**MAINE DEPARTMENT OF
INLAND FISHERIES AND WILDLIFE**

ADDENDUM NO. 2

**EFFLUENT CHARACTERISTIC DESIGN AT
EMBDEN REARING STATION**

BGS PROJECT NO.: 3289

OVERALL ELECTRICAL PLAN

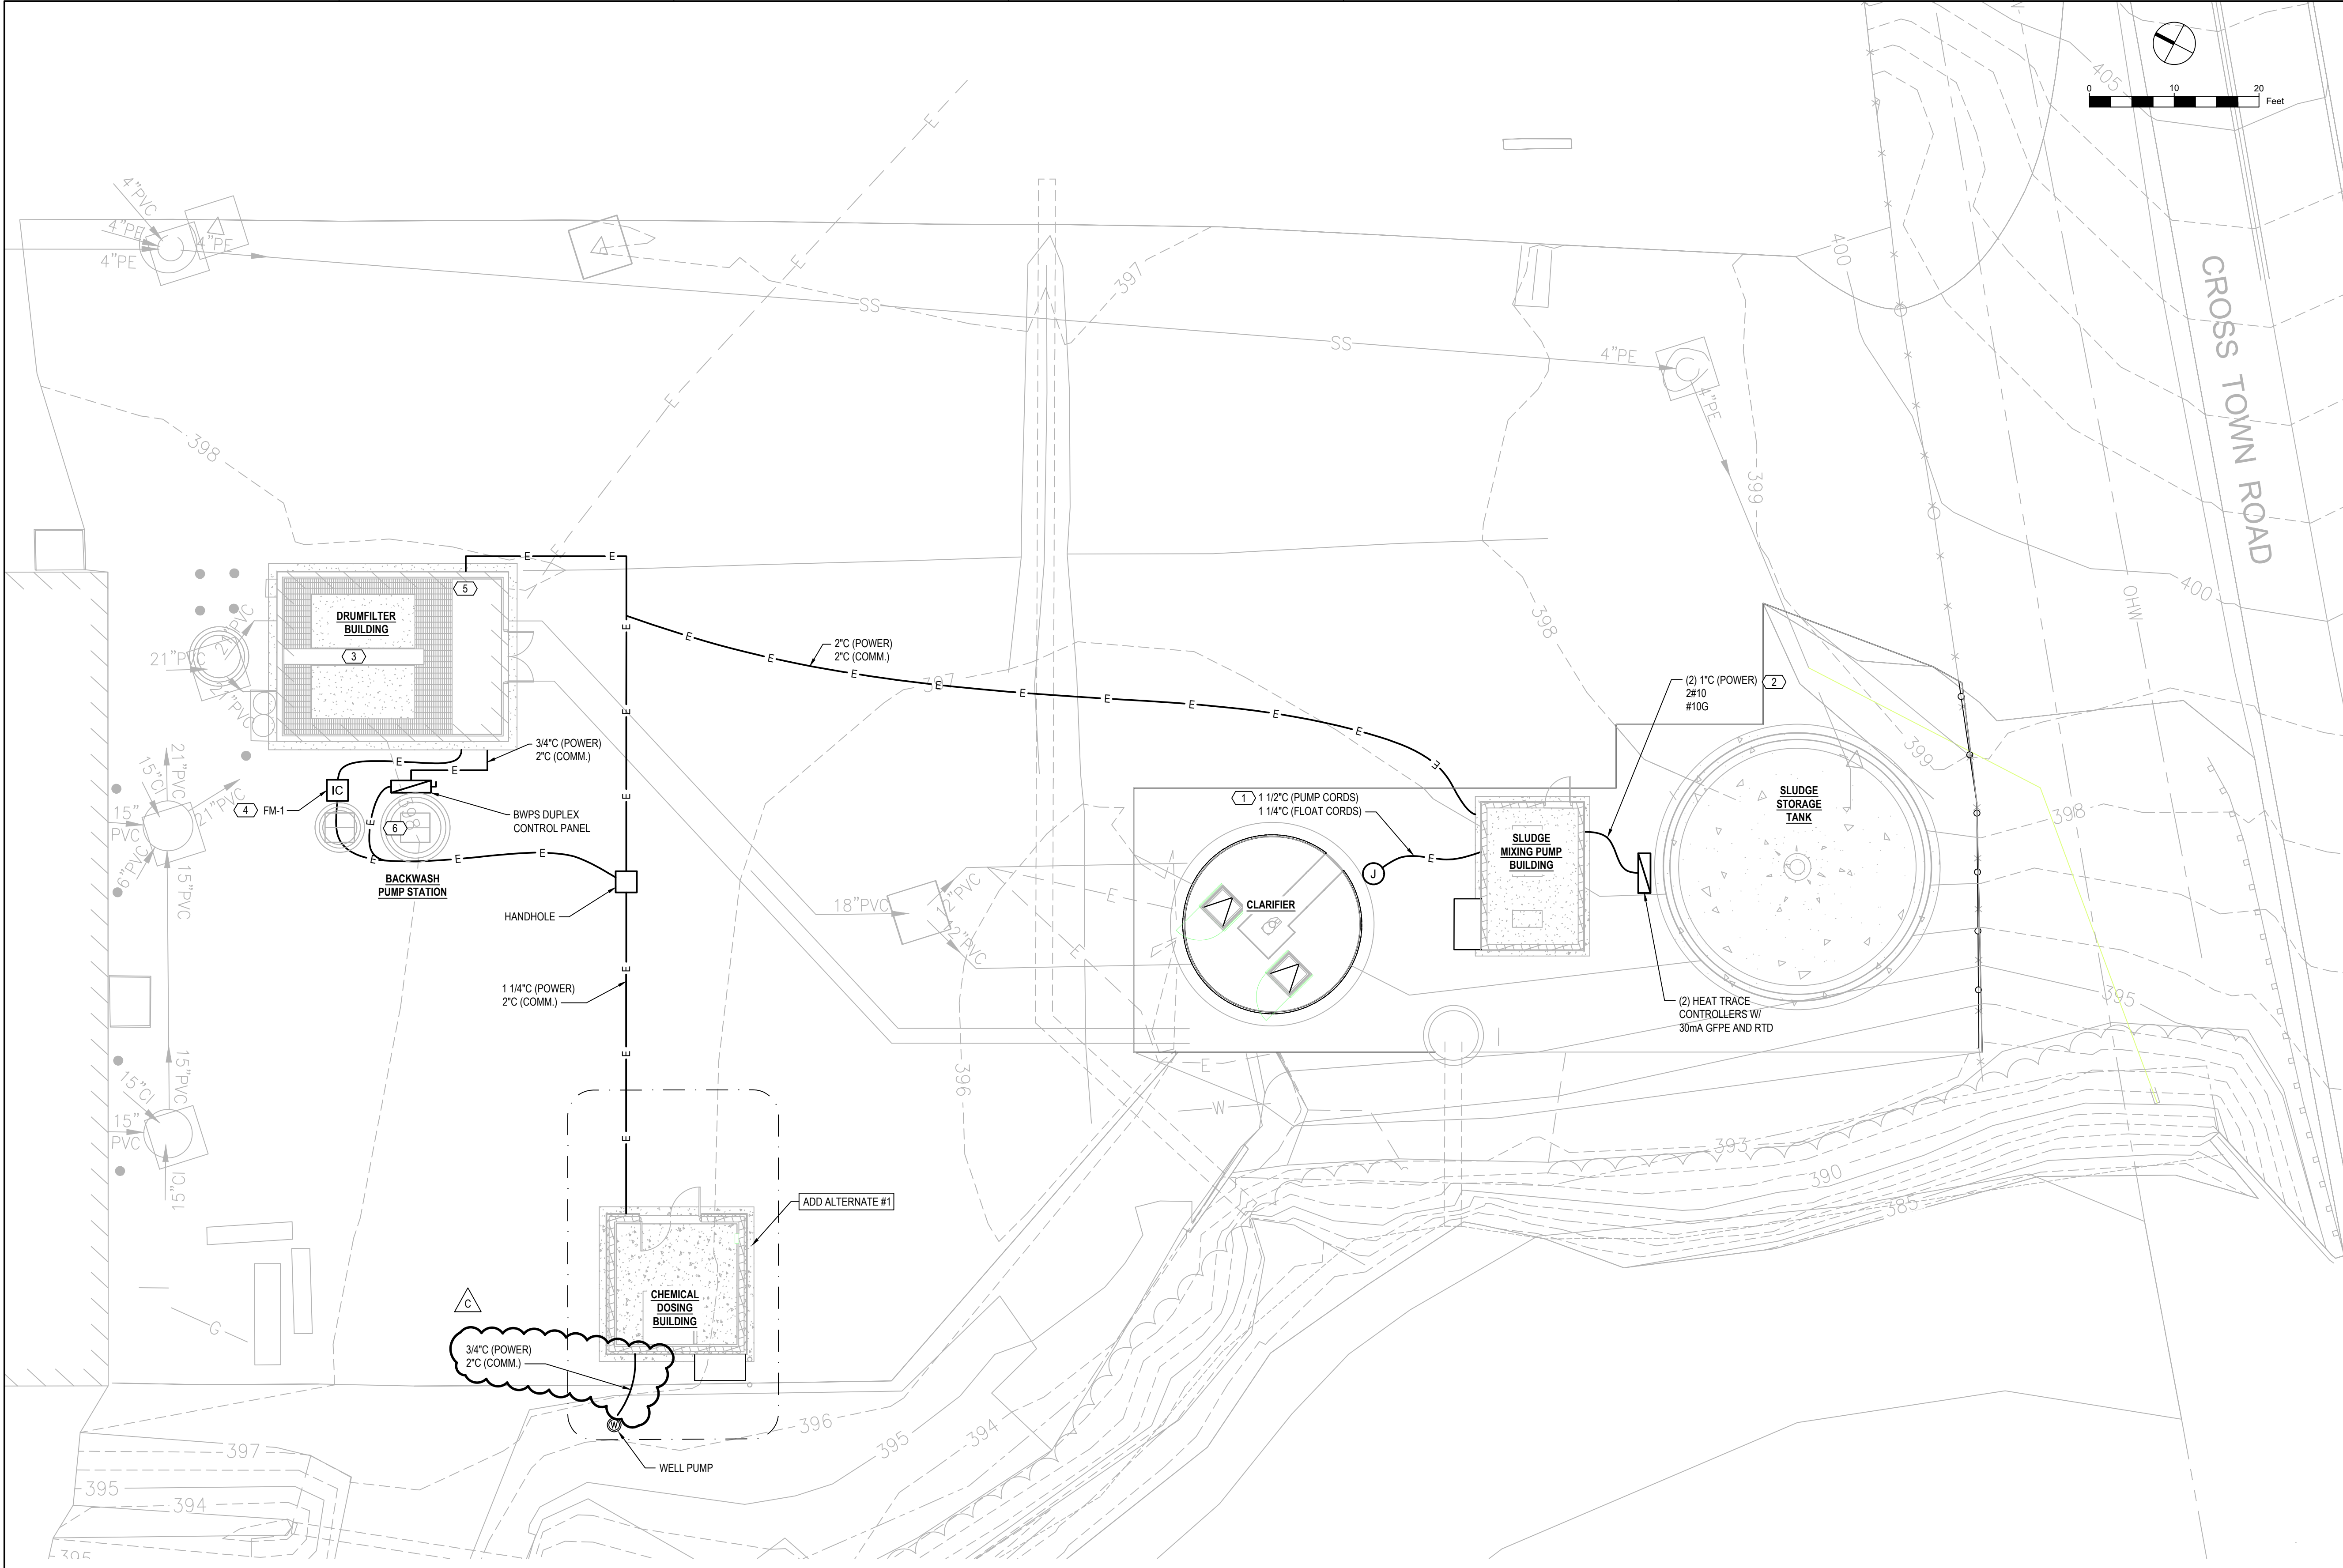
- a. Are the clarifier and backwash control panels supposed to be furnished with the equipment?
 - b. Drawing 10E-502: Is the alarm panel existing and are we adding wiring or is this a complete new system?
 - c. Drawing 11E-101: No electrical shown to the clarifier or sludge storage tank. Is there any wiring associated with these? For example, is there a clarifier drive motor? Are there level instruments in the sludge tank?
 - d. Drawing 10E-651: Panel E2 shows circuits for heat trace. Where is the heat trace located?

ANSWER: MH 11 should be labeled as MH 15.
SOURCE: Eva Schaible eschaible@phelanconstruction.com Thu 10/17/2024 11:49
35. **QUESTION:** 11E-101 : OVERALL ELECTRICAL PLAN: Confirm the scope / extent of work of the power and comm for Alternate # 1. Is the connection to the Chemical Dosing Building as full Alternate # 1 from Drum Filter Building?

36. **QUESTION:** 11E-101 : OVERALL ELECTRICAL PLAN: Chemical Dosing Building Add Alt # 1: Please confirm the propane tank specification and pad location in all drawings.

- a. Yes, both control panels are to be furnished with the equipment.
- b. This is to be a completely new system.
- c. The drawing has been modified with additional information.
- d. Refer to the revised drawing 11E-101.
- e. See Section 33 11 15 – Water Wells, inclusive of addenda.

ANSWER: Only conduit installation up to the limits as shown on plan are part of base bid.
SOURCE: Eva Schaible eschaible@phelanconstruction.com Thu 10/17/2024 11:49

ANSWER: Pads are shown on plan sheets.
